Access Compliance Report

Public Rights-of-Way

(Pedestrian Signals)

Intersection ID: N/A	Main Street:	Cross Street: N/A	Location: N/A
ADA ID: 5DCF23BA9B54	Signal Type: One Push Button-APS	Overall Compliance: No	Severity Score: BTN 1: N/A BTN 2: N/A No BTN: N/A
Codes/Mitigation Info/Possible Solution		Field Measurements/Component Compliance

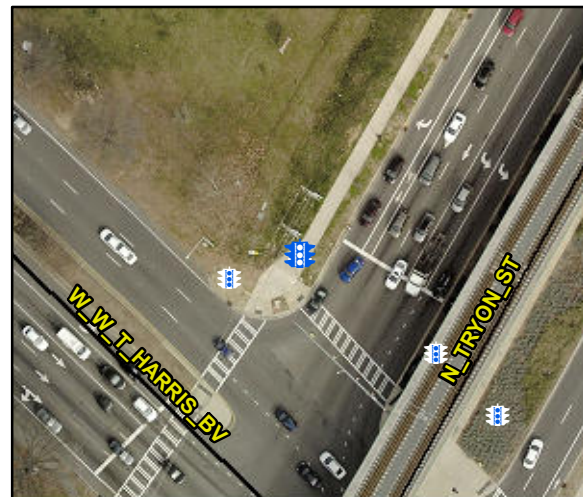
Surveyor Notes: NOT HOOKED UP, NOISES
AND VERBAL COMMANDS UNKNOWN

PROW/ADA: R404.2, R404.3, R404.7.2,
R104.2, R209.1, TMUTCD 4e.10, MUTCD
4e.08,

Possible Solutions: Remove & Replace
Replace APS Button With New APS Button.
Remove and Replace Clear Space.
